Access Compliance Report

Public Rights-of-Way

(Curb Ramps)

Intersection ID: 44701	Main Street: MARY_BLAIR_LN	Cross Street: EAGLES_LANDING_DR	Location:	N
ADA ID: D31A418F604B	Ramp Type: PerpDiag	Initial Pass/Fail: Fail	Overall Compliance: No	Severity Score: 33.75

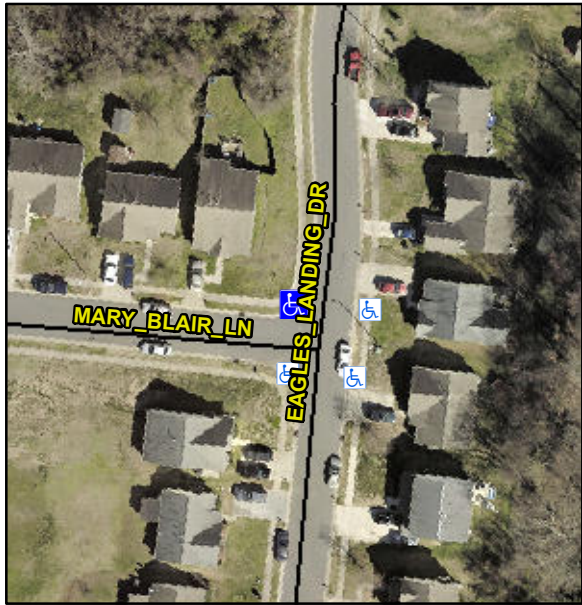
Codes/Mitigation Info/Possible Solution			Field Measurements/Component Compliance					
 Street 1 Name MARY BLAIR LN Stop Condition-Street 2 StopSign Street 2 Name EAGLES LANDING DR Stop Condition-Street 1 None	Possible Solutions:		Compliance	Description	Data	Compliance	Description	Data
	Remove & Replace Curb Ramp With Two New Directional Ramps or Equivalent.		N/A	Ramp Length (in)	47.0	Yes	Ramp Slope (%)	5.0
			No	Ramp Width (in)	47.5	No	Ramp XSlope (%)	8.2
			N/A	Flare Type LT	N/A	N/A	Flare Type RT	N/A
			N/A	Flare Slope LT (%)	N/A	N/A	Flare Slope RT (%)	N/A
			N/A	Flare Traversable LT?	N/A	N/A	Flare Traversable RT?	N/A
			N/A	Landing Length (in)	N/A	N/A	DWS Provided?	N/A
			N/A	Landing Width (in)	N/A	N/A	DWS Contrast?	N/A
			N/A	Landing Slope (%)	N/A	N/A	DWS Length (in)	N/A
			N/A	Landing X Slope (%)	N/A	N/A	DWS Full Width?	N/A
Surveyor Notes:		N/A	N/A	Landing Curb? (Y/N)	N/A	N/A	DWS Offset (in)	N/A

PROW/ADA:			N/A	Shared Landing?	N/A			
Not Found, R304.5.1, R304.5.3			N/A	Gutter Ponding?	N/A	N/A	Gutter Slope (%)	N/A
			N/A	Gutter Lip Ht (in)	0.5	N/A	Gutter X Slope (%)	N/A
			N/A	Painted X Walk1?	No	N/A	Painted X Walk2?	No
				X Walk 1 Direction	To S		X Walk 2 Direction	To E
			N/A	X Walk 1 Width (in)	N/A	N/A	X Walk 2 Width (in)	N/A
				X Walk 1 Slope (%)	6.0		X Walk 2 Slope (%)	2.1
				X Walk 1 X Slope (%)	4.1		X Walk 2 X Slope (%)	7.6
			N/A	Ramp inside XWalk1?	N/A	N/A	Ramp inside XWalk2?	N/A
				Road Slope (%)	6.7	N/A	Clear Space?	N/A
				Road X Slope (%)	4.2	N/A	Clear Space to XWalk (in)	N/A
			N/A	Any Obstructions?	N/A	N/A	Storm Grate/Utility Hazard?	N/A
				Obstruction Type			Storm Grate/Utility Type	
					N/A			N/A
						Yes	Surface Condition? (G/P)	Good
Total Cost:		\$ 3200.00
